TRANS/WP.29/GRSG/66
26 November 2004

Working Party on General Safety Provisions (GRSG)

**REPORT OF THE WORKING PARTY ON GENERAL SAFETY PROVISIONS (GRSG)
ON ITS EIGHTY-SEVENTH SESSION**

(12 to 15 October 2004)

Figure A5.2.-Dimensions for the anthropomorphic ballast"

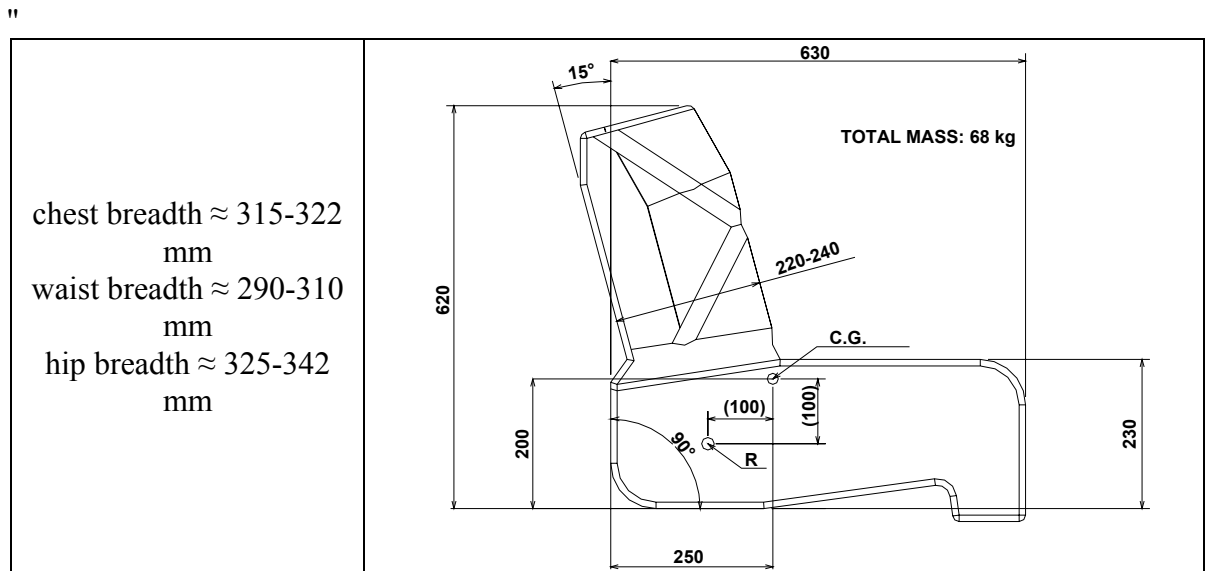
Paragraphs 2.1.5 to 2.1.5.2.2., amend to read:

- "2.1.5. In the case where occupant restraint devices are part of the vehicle type, a mass shall be attached to each seat fitted with an occupant restraint following one of these two methods, at the choice of the manufacturer:
- 2.1.5.1. First method: That mass shall be:
- 2.1.5.1.1 50 per cent of the individual occupant mass (M_{mi}) of 68 kg.
- 2.1.5.1.2 Placed to have its centre of gravity 100 mm above and 100 mm forward of the R point of the seat as defined in Regulation No. 21, annex 5.
- 2.1.5.1.3 Fixed rigidly and securely so that it does not break away during the test.
- 2.1.5.2 Second method: That mass shall be:
- 2.1.5.2.1. An anthropomorphic ballast with a mass of 68 kg, restrained with a 2 point seat-belt. The ballast must allow guiding and positioning for safety belts.
- 2.1.5.2.2. Placed to have its centre of gravity and dimensions according Figure A5.2."

Insert the following figure A5.2.:
